DART SERVICE INSTRUCTION

TO AMEND INSTALLATION INSTRUCTIONS IIN-D412-742 REV. D
AND INSTRUCTIONS FOR CONTINUED AIRWORTHINESS ICA-D412-742 REV. 3

REF. CANADIAN STC: SH05-37

REF. FAA STC: SR01583SE

FIGURE 1: D3391-011/-021 FWD TUBE ASSEMBLY

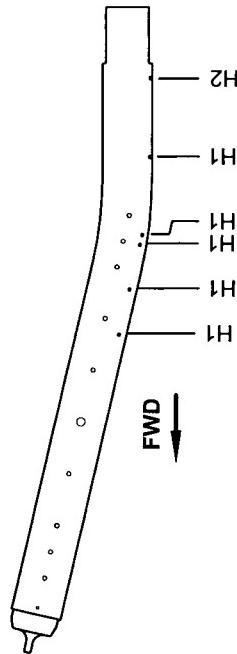
The purpose of this service instruction is to provide instructions to replace the stainless steel NAS1330S3KB inserts used to attach the wearplates with cad-plated steel AEELS-1032 inserts. Instructions are also provided for the removal of LPS-3 corrosion inhibitor.

- (c) Counterbore indicated holes per Figures 1-3 and Table 1 of this service instruction using Ø7/16" c'bore bit with Ø1/4" c'bore pilot.
 - (d) Open holes with Ø19/64" drill bit (Ø0.297").

- (e) Touch up holes with chemical film (Alodone 1200 or 1201) per MIL-C-5541.
 - (f) Install AEELS-1032-XXX inserts per Figure 1-3 and Table 1 of this service instruction.

HOLE	C'BORE dia. x depth	DRILL SIZE	INSERT
H1	N/A	Ø0.297"	AELS-1032-225
H2	Ø0.438" x 0.040"	Ø0.297"	AELS-1032-130
H3	N/A	Ø0.297"	AELS-1032-130
H4	Ø0.438" x 0.040"	Ø0.297"	AELS-1032-130
H5	Ø0.438" x 0.170"	Ø0.297"	AELS-1032-225
H6	Ø0.438" x 0.170"	Ø0.297"	AELS-1032-130
H7	N/A	Ø0.297"	AELS-1032-130
